Modification of Development Consent

File: SSD 7348 MOD 9

Modification to the Oakdale West Estate Concept Plan including:

- changes to layout of Buildings 2A, 2C, and 2D
- increase of the maximum height of Building 2C from 15 m to 22.2 m

Figure 1: Concept Proposal Layout (MOD 9)

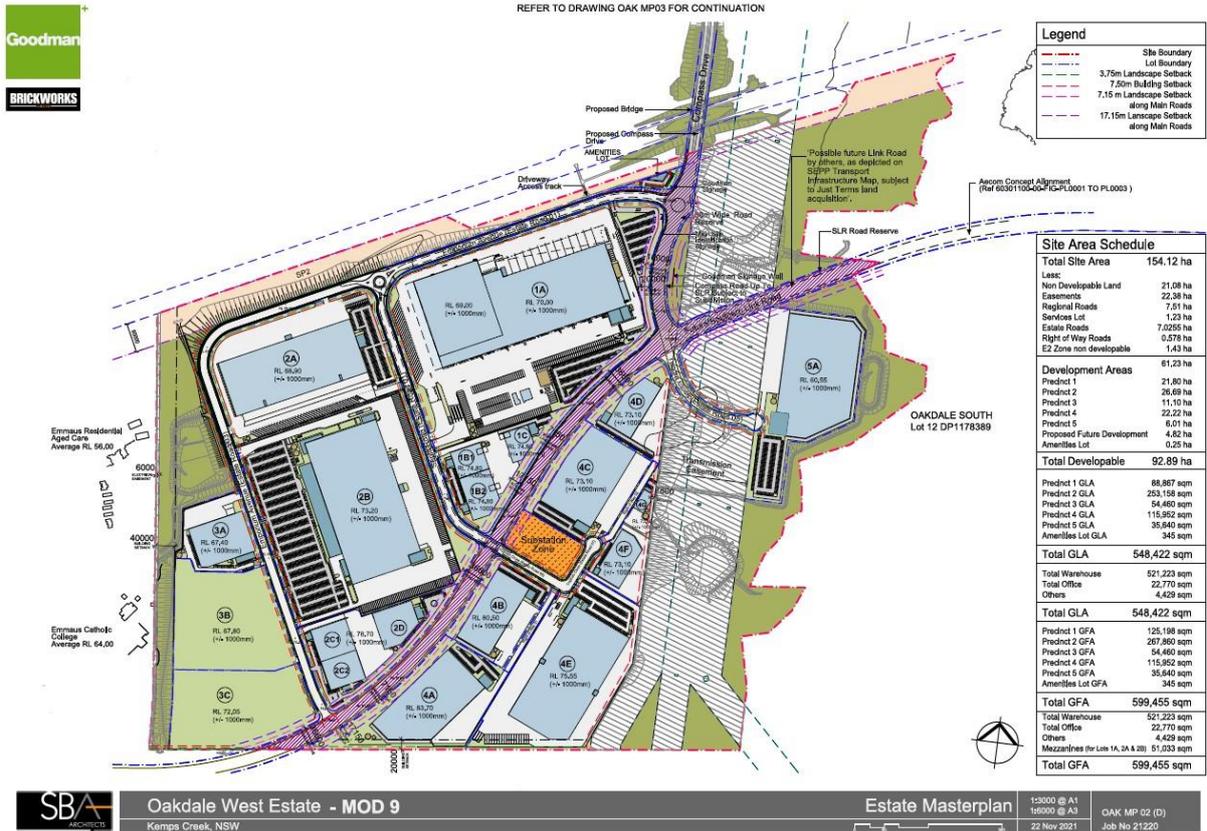
5. Replace Figure 1 in Appendix 1 with a new figure as follows:
